HISTORIC AND DESIGN REVIEW COMMISSION

September 06, 2023

HDRC CASE NO: 2023-337
ADDRESS: 419 WICKES
LEGAL DESCRIPTION: NCB 2881 BLK 6 LOT 11
ZONING: RM-4, H
CITY COUNCIL DIST.: 1
DISTRICT: King William Historic District
APPLICANT: Jacob Williams/WILLIAMS JACOB CHARLES & CHEVALIER KARINA
OWNER: Jacob Williams/WILLIAMS JACOB CHARLES & CHEVALIER KARINA
TYPE OF WORK: Front porch post installation, handrail installation, removal of porch plinths
APPLICATION RECEIVED: August 14, 2023
60-DAY REVIEW: October 13, 2023
CASE MANAGER: Jessica Anderson
REQUEST:

419 wickes

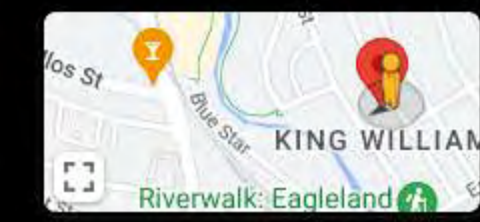
- c. PLINTH REMOVAL: The applicant requests to remove the plinths found on either side of the front steps. Historic Design Guidelines for Exterior Maintenance and Alterations 7.B.iv says to design replacement elements, such as stairs, to be simple so as to not distract from the historic character of the building. Do not add new elements and details that create a false historic appearance. Staff reviewed images available via street view and found that in October 2007, the earliest image available via Google, the house had battered plinths clad in shake to match the battered skirting. The house retained the battered plinths until at least July 2014, and by March 2016 they were replaced by what appear to be plywood plinths. Staff finds that the plinths removed, though significantly altered over time, were the same size and footprint as found historically, are a character-defining feature of the Craftsman style, and should be returned.

Staff does not recommend approval of item 1, removal of the plinths found on each side of the front steps, based on finding c. Staff recommends the plinths be reconstructed based on images available of the house from c. Oct 2007 until c. July 2014.
